Subject: Fifth Ten Year Inservice Inspection Interval, Relief Request No. 15-ON-001;
Alternative to Defect Removal Prior to Repair/Replacement Activities on Low Pressure
Service Water System Piping

Relief Request Serial #15-ON-001: Relief Request in Accordance with 10 CFR 50.55a(z)(2) to use an Alternative to Defect Removal Prior to Performing Repair/Replacement Activities on Low Pressure Service Water System Piping

Attachment 1: Engineering Change EC 114408 Sketches 1 through 7

DUKE ENERGY
OCONEE NUCLEAR STATIONEC 114408 /001
SKETCH 1

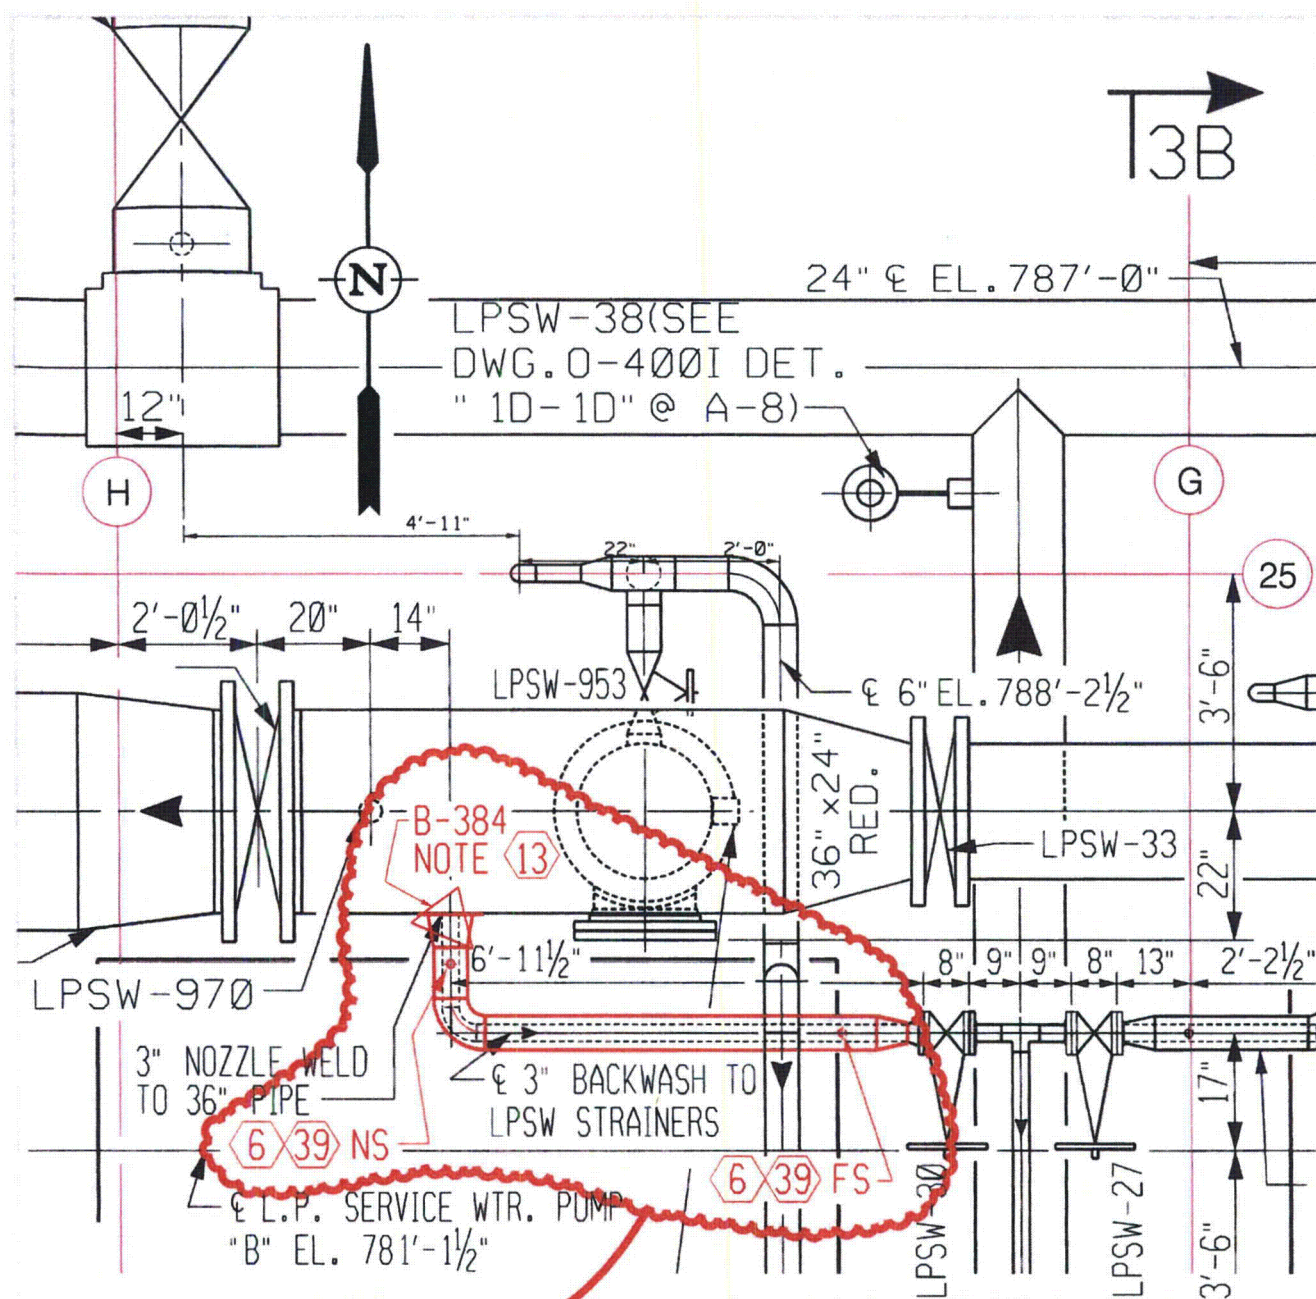
3. 1/2" THRU 10" SCH. 40
12" THRU 48" STD.
7. STAINLESS STEEL (PS-151.4) MAY BE SUBSTITUTED FOR PIPE SIZES 1/2" THRU 6". EXISTING PIPING MAY BE OF AUSTENITIC STAINLESS STEEL MATERIAL OR OF CARBON STEEL TO THE APPLICABLE "PS" INDICATED. PIPING ENGINEERING APPROVAL IS REQUIRED PRIOR TO ANY CHANGE OF THE EXISTING MATERIAL. SEE NOTE 24 IN APPENDIX C, MATERIAL REQUIREMENTS, OF OS-243.00-00-0001.
8. 8", 6" & 3 1/2" PIPE AND FITTINGS ADDED TO MAINTAIN PRESSURE BOUNDARY DUE TO SIGNIFICANT CORROSION OF 3" PIPE WALL THICKNESS.

EC 114408/001
SKETCH 2

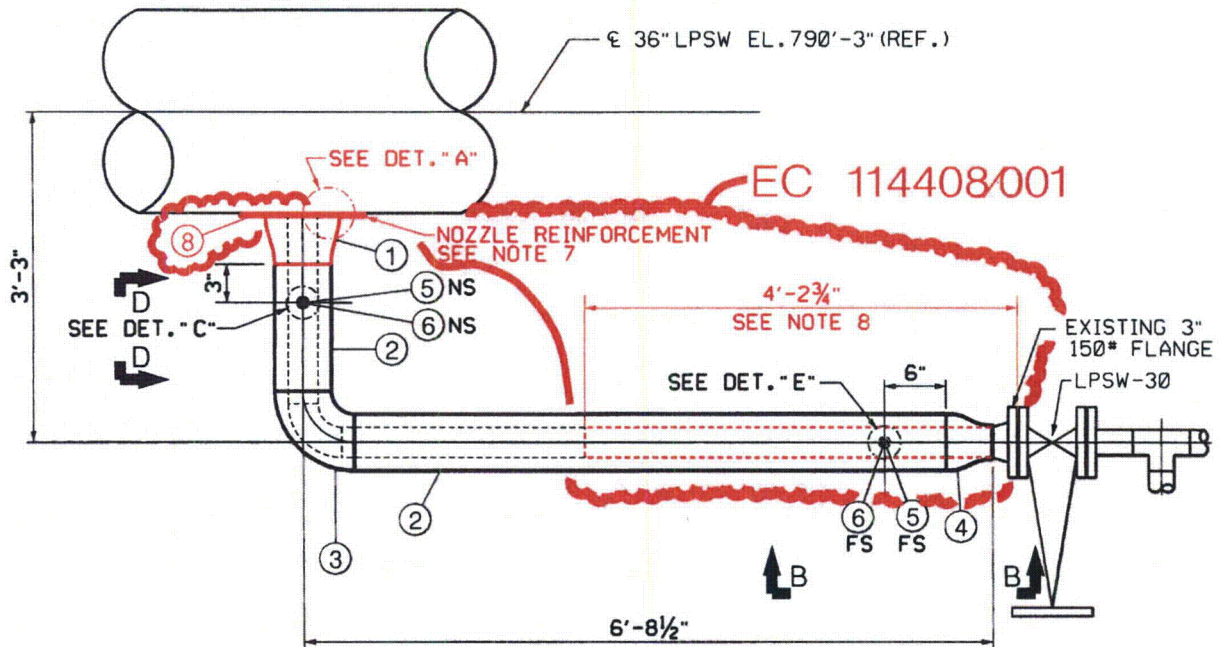
SEE SKETCH 3
FOR ENCAPSULATED
PIPE DETAILS

EC 114408/001
SKETCH 3

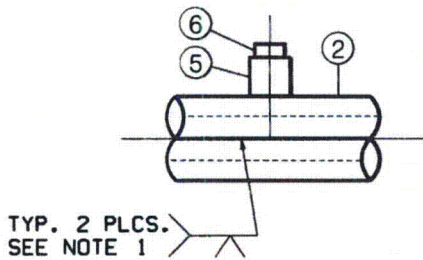
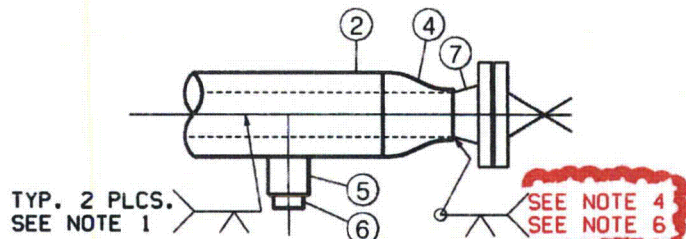
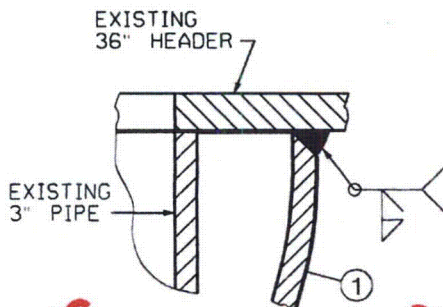
NOZZLE REINFORCEMENT PAD NOT SHOWN FOR CLARITY.

DUKE ENERGY
OCONEE NUCLEAR STATIONEC 114408/001
SKETCH 5

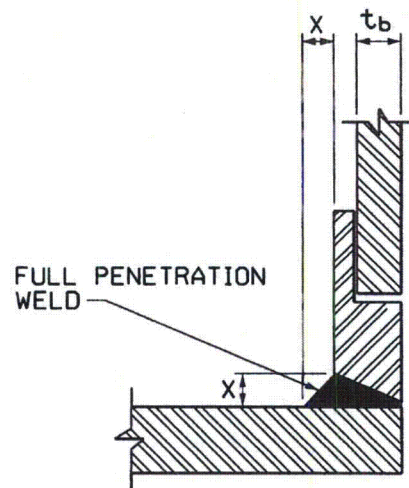
THIS SKETCH IS INCLUDED ONLY
TO PROVIDE WELDING INFORMATION.
THERE ARE NO CHANGES
TO O-499C PER EC114408 /001.

EC 114408/001
 SKETCH 6

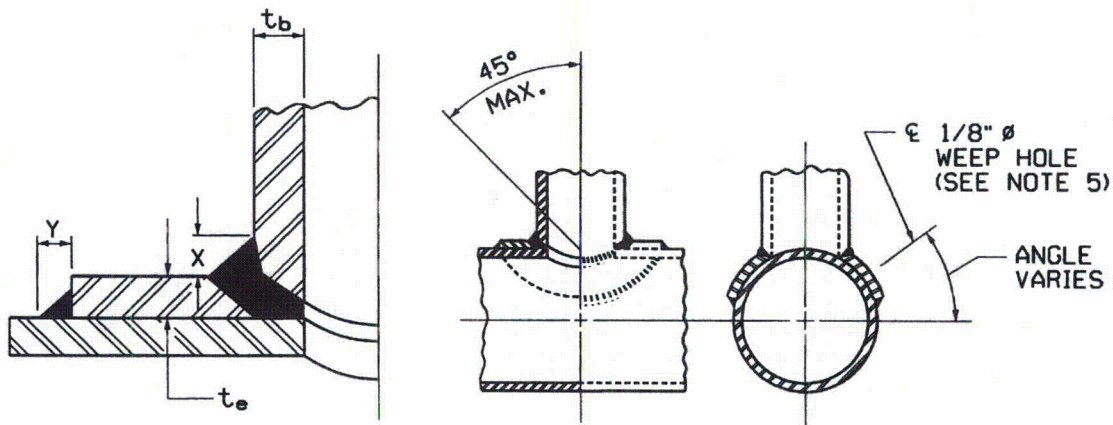
THIS SKETCH IS INCLUDED ONLY
 TO PROVIDE WELDING INFORMATION.
 THERE ARE NO CHANGES
 TO O-499C PER EC114408 /001.
